## Technical News Bulletin

Cham, September 2016

### Precise rigid Baffle Pantograph 4 ¼ & 5” Support

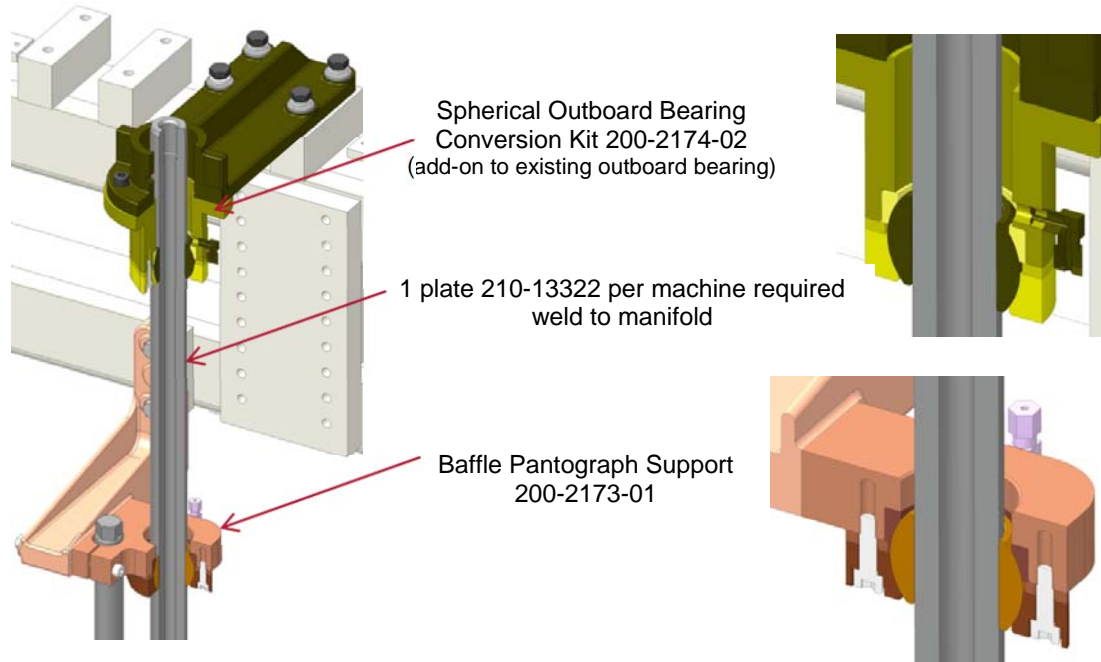
The new spherical outboard bearing for the 4 ¼ and 5” Baffle Pantograph is combined with an extra stiff bracing swivel to support the Pantograph guide rod precisely. A better performance and an extended equipment life time is the added value.

It is the standard on all new machines with Baffle Pantograph 4 ¼ and 5". Field upgrades are possible by purchasing the required parts.

Field upgrade on Emhart machines are straight forward. One plate 210-13322 per machine needs to be welded to the manifold.
